Model: Cattleya		Date: 15-Jun-99	No.: RA257001
Subject: Silicone Oil for the Fusing Unit		Prepared by: H. Matsui	
From: Technical Service Dept., GTS Division			
Classification:	<input type="checkbox"/> Troubleshooting <input type="checkbox"/> Mechanical <input type="checkbox"/> Paper path <input type="checkbox"/> Other (      )	<input type="checkbox"/> Part information <input type="checkbox"/> Electrical <input type="checkbox"/> Transmit/receive	<input type="checkbox"/> Action required <input checked="" type="checkbox"/> Service manual revision <input type="checkbox"/> Retrofit information

Model: Cattleya		Date: 15-Aug-99	No.: RA257002
Subject: Firmware-related Information		Prepared by: H.Matsui	
From: Technical Service Dept., GTS Division			
Classification:	<input type="checkbox"/> Troubleshooting <input type="checkbox"/> Part information <input type="checkbox"/> Action required <input type="checkbox"/> Mechanical <input checked="" type="checkbox"/> Electrical <input type="checkbox"/> Service manual revision <input type="checkbox"/> Paper path <input type="checkbox"/> Transmit/receive <input type="checkbox"/> Retrofit information <input type="checkbox"/> Other (      )

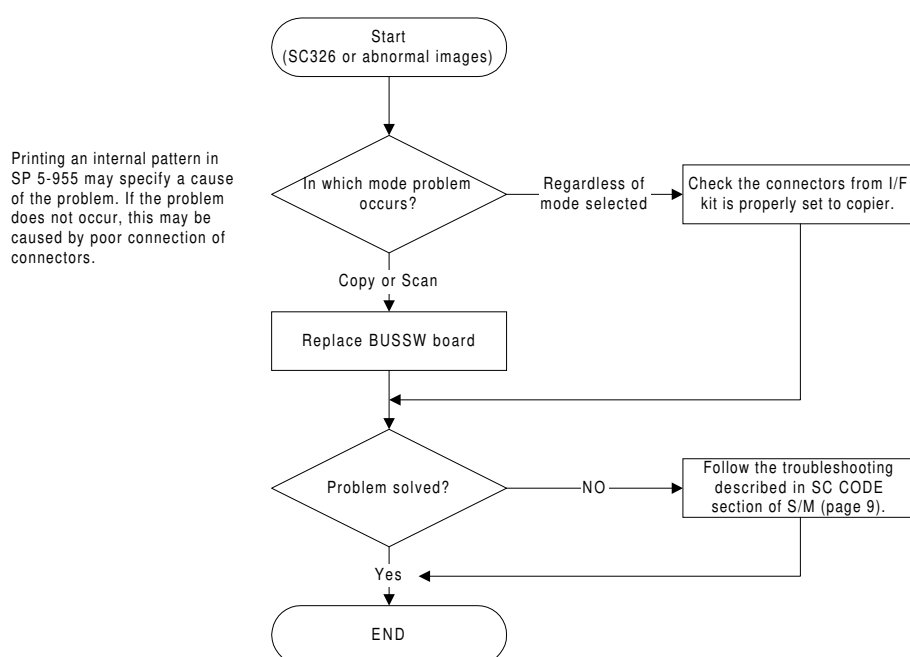
The BUSSW board has been modified as shown below. The board thought to be causing the problem is #A8485111. The problem does not occur with the Interface Kits containing #A8485112, as this board does not use IC18.

Picture from an old unit

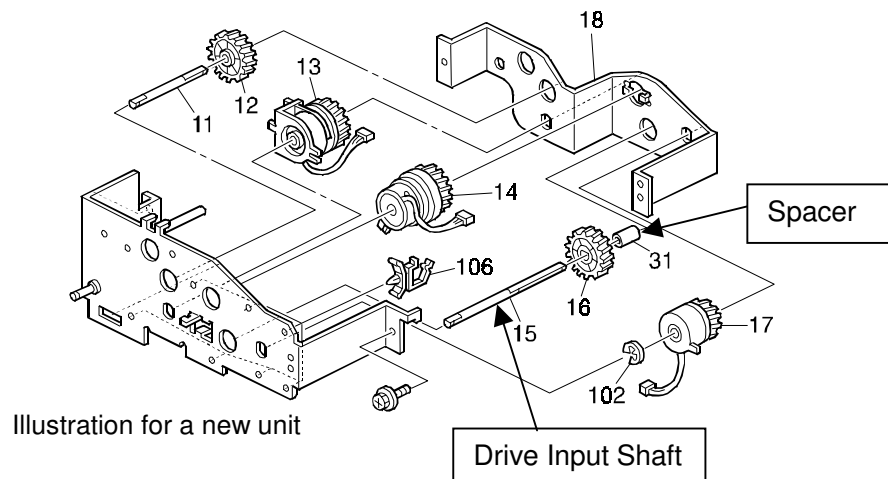
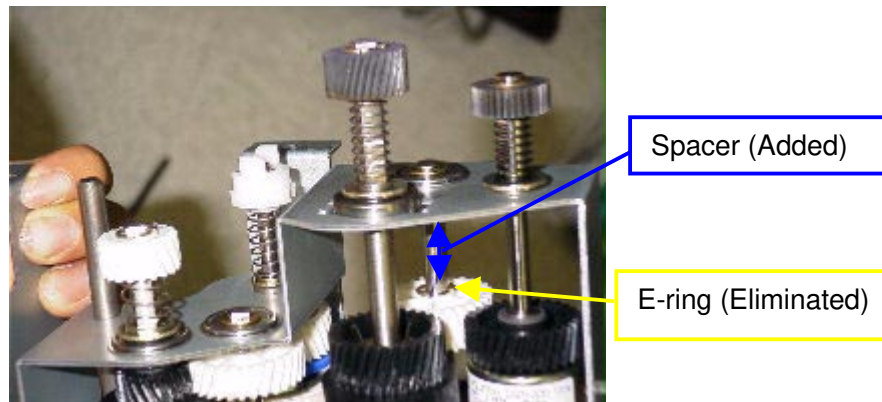
When using the ultra smoothing tape, remove the spacer (0.1 mm) between the tightener and the stepped screw. (March production does not have the spacer.)

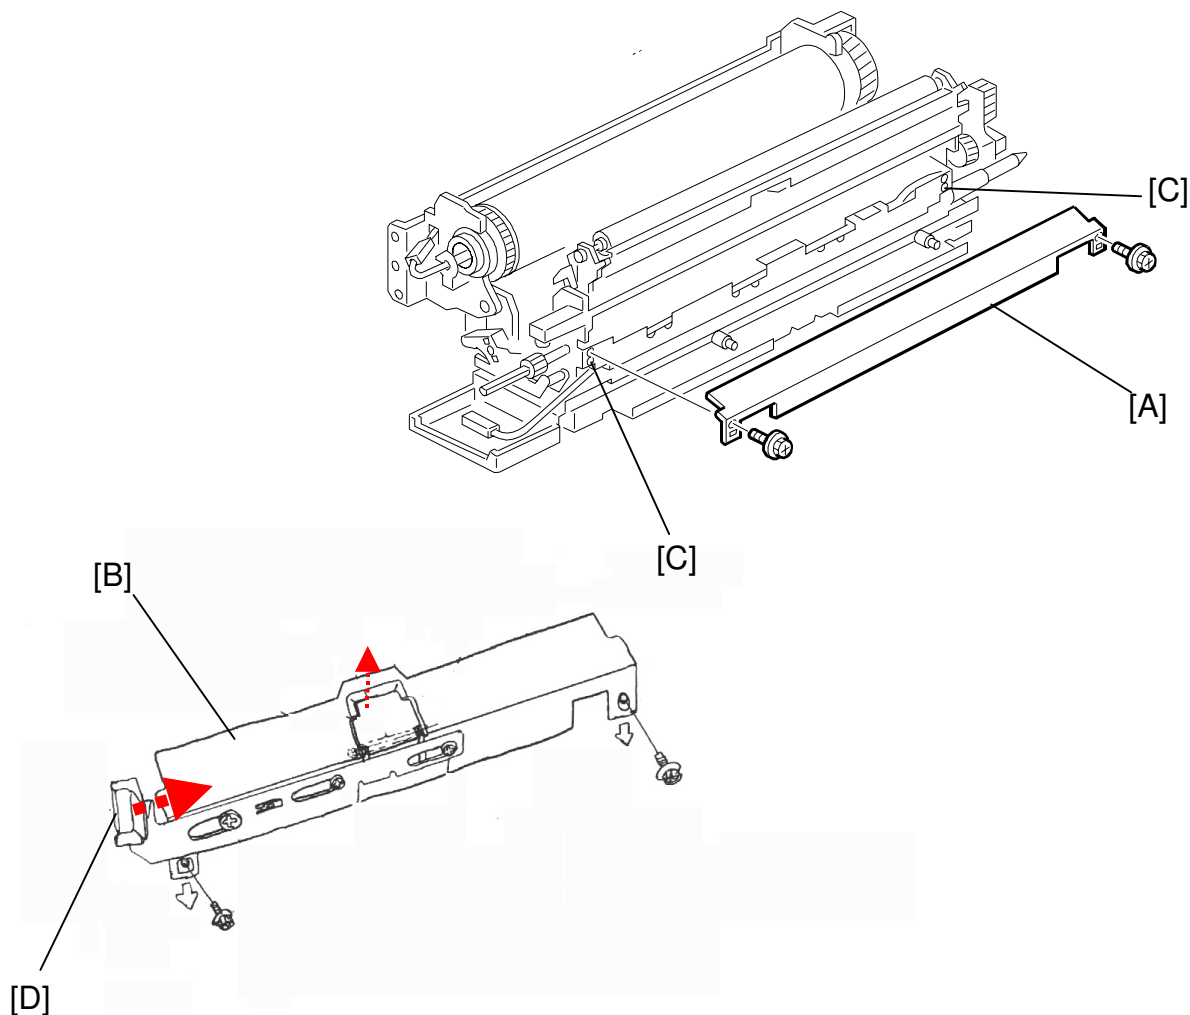
1. Remove the fusing unit from the copier.
2. Remove the fusing entrance guide [A] (2 screws).
3. Install the new fusing entrance guide [B] at the lowest position and secure it by using the screw holes [C] located 10 mm below the original screw holes (2 screws).
4. Stick an explanation decal on the paper transport tank as shown on the next page.
5. Reinstall the fusing unit.
6. Change the fusing entrance lever position [D] depending on the paper thickness:
  - Inward position (in the direction of the dotted arrow): for extra thick paper
  - Outward position: for normal and thick paper

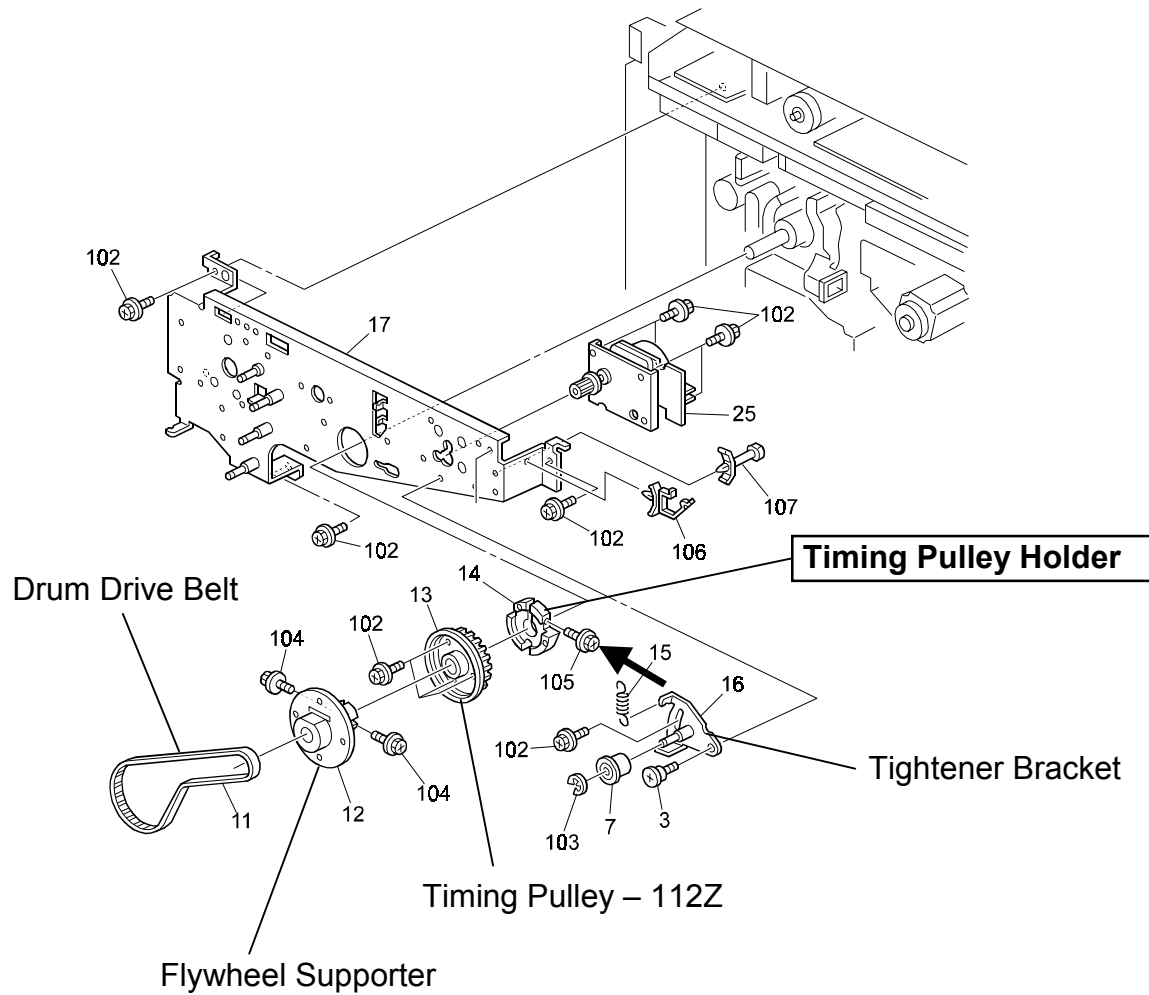
The Timing Pulley has been modified in order to minimize the image misalignment. This change was applied to the production line from September 1999. In addition, the part number has been changed from A2574663 to A2574680.  
Please refer to MB No. MA257029 for details.

Remove the large and small flywheels, the flywheel supporter, and the timing pulley – 112Z. Refer to the illustration on the next page.

When attaching the flywheel supporter, make sure to tighten the screws firmly on a flat surface. This will prevent horizontal black or magenta lines at 106 mm from the leading edge. Refer to RTB No. RA257006.

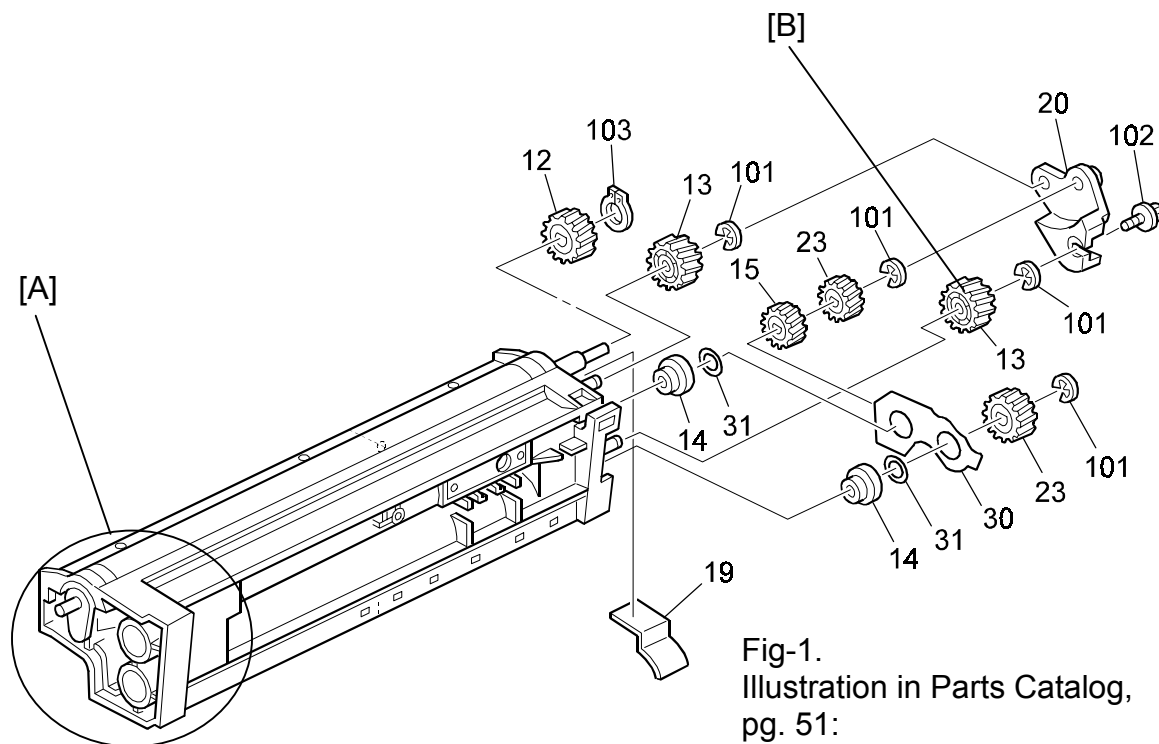
1. The material of the development idle gear has been changed from plastic to metal.  
A2573155 (plastic) → A2573158 (metal)
2. A strip of Mylar (A2573079: call-out #30, fig.1) has been added between the bearings and the development gears to protect the gears from development carrier.

If this problem occurs in the field, replace the old development idle gear (A2573155) with the new type (A2573158).

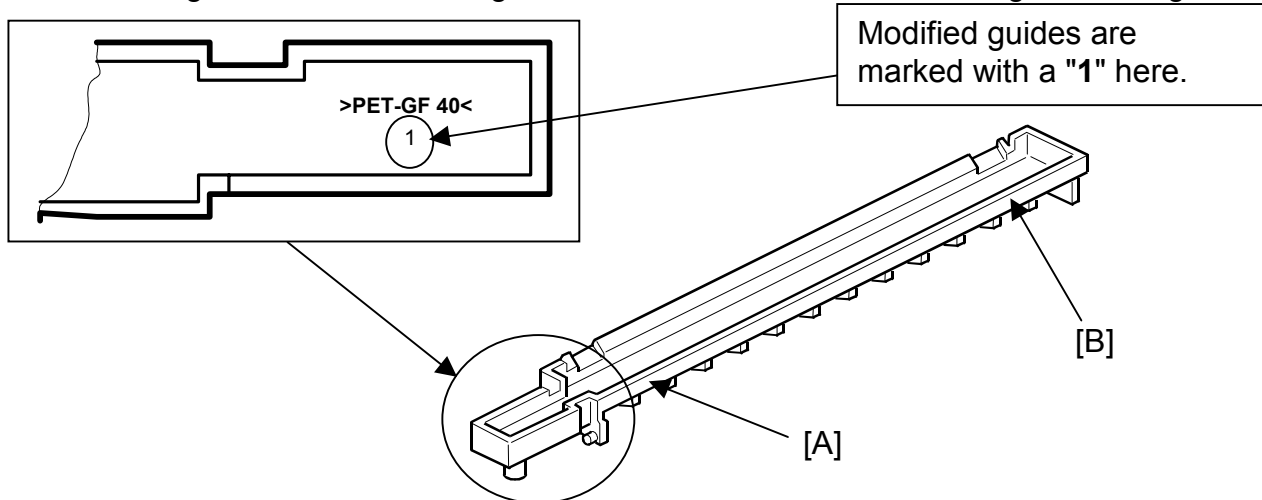
The plastic mold used for the fusing entrance guide has been improved to remove the molding line. One of the two openings (gates) in the plastic mold for injecting plastic has been removed, creating one flow of plastic inside the mold

Older (pre-modification) guides have **2** burrs created by molding gates, which are located in positions [A] and [B]. Modified guides only have **1** burr, which is located at position [A].

If you receive any customer complaints about oil streaks on copies, check the bottom surface of the fusing entrance guide for an oil leak. If any oil is found, replace the entrance guide with a new type.

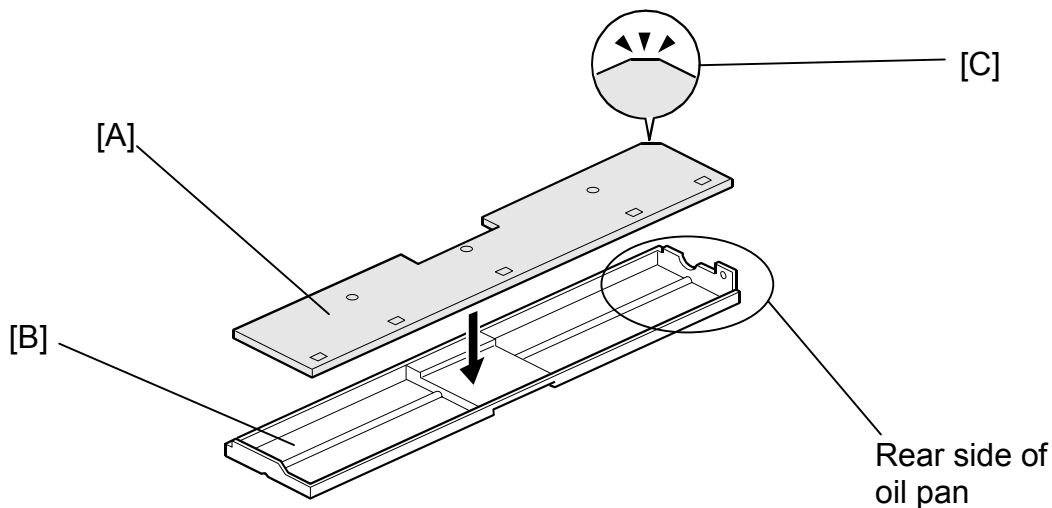
An oil pan felt [B] has been added to absorb the accumulated oil in the oil pan. Another oil pan felt [C] has also been added to return the oil in the oil pan to the pressure roller, via the existing pressure roller oil supply pad [D].

At the next service visit, please check if there is an excessive amount of fusing oil in the oil pan. If there is, add the oil pan felt and oil pan felt bracket.

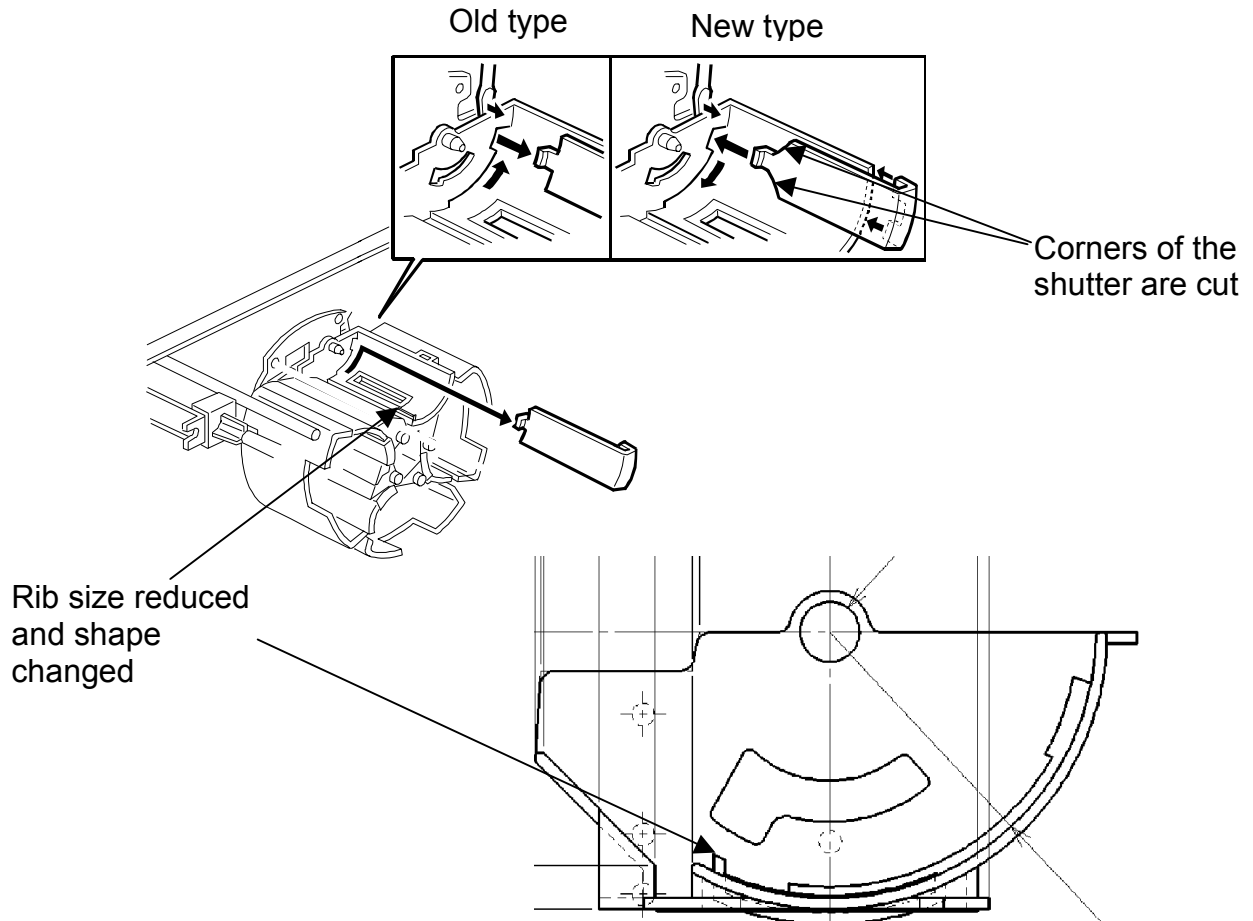
1. To reduce the friction between the toner cartridge and cartridge lever, three ribs have been added to the toner cartridge surface, on which the toner cartridge lever normally slides. This will help to ensure proper lever rotation, since the lever will not directly contact the cartridge surface.

2. The shapes of the toner hopper shutter and toner hopper ribs have been modified. Before the modification, excessive torque was applied to the shutter during cartridge lever rotation, causing the edge of the shutter to catch on the toner hopper ribs. After the modification, the shutter does not catch on the toner hopper ribs.

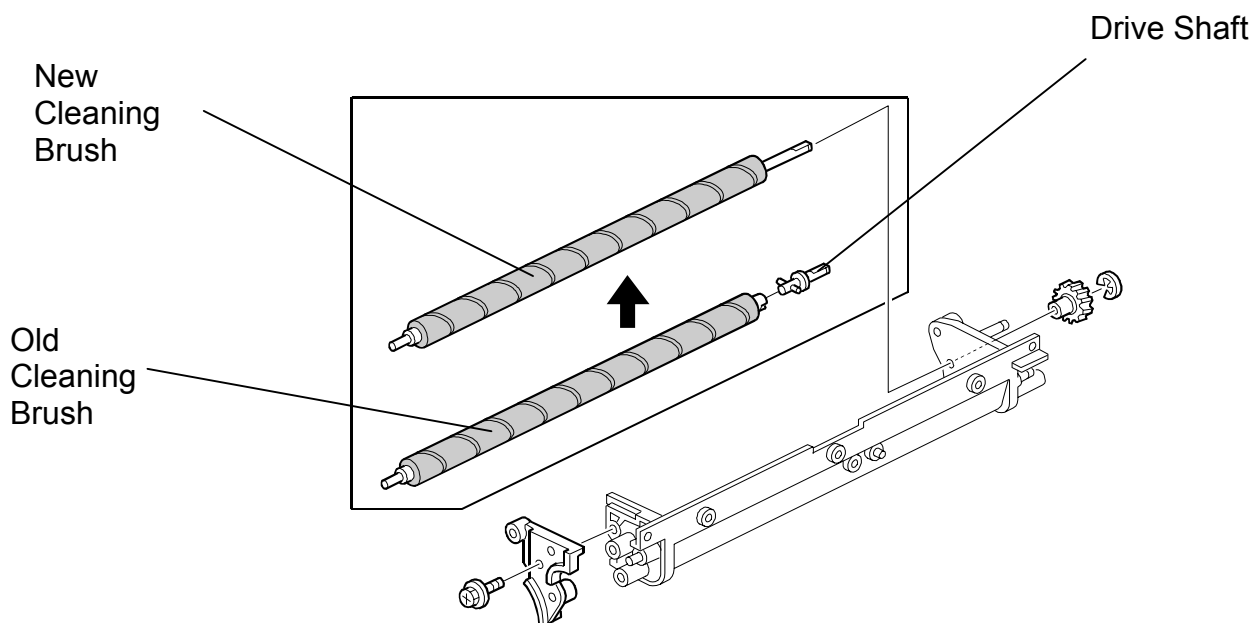
As announced in MB #MA257099, the Drum Cleaning Brush has been changed to include the Drive Shaft (illustration below). This RTB contains the PM replacement procedure for the Drum Cleaning Brush.

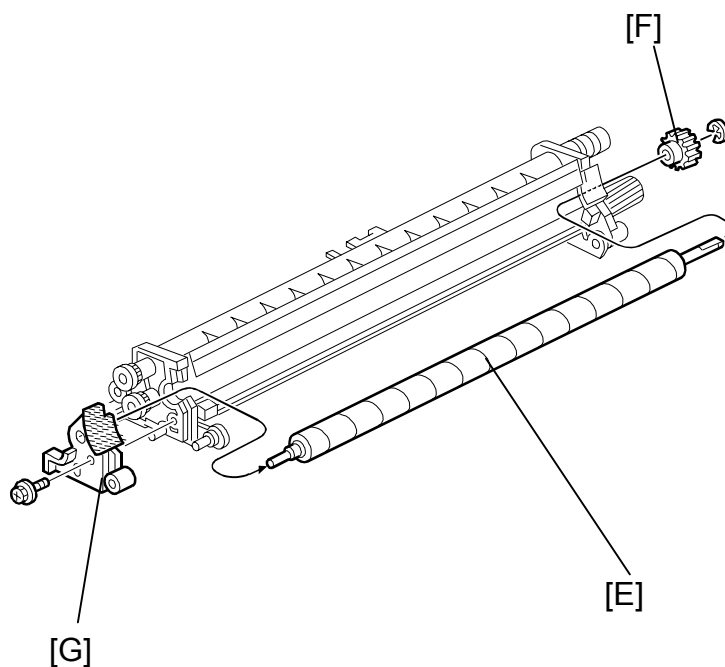
NOTE: The Drive Shaft [C] is no longer required.
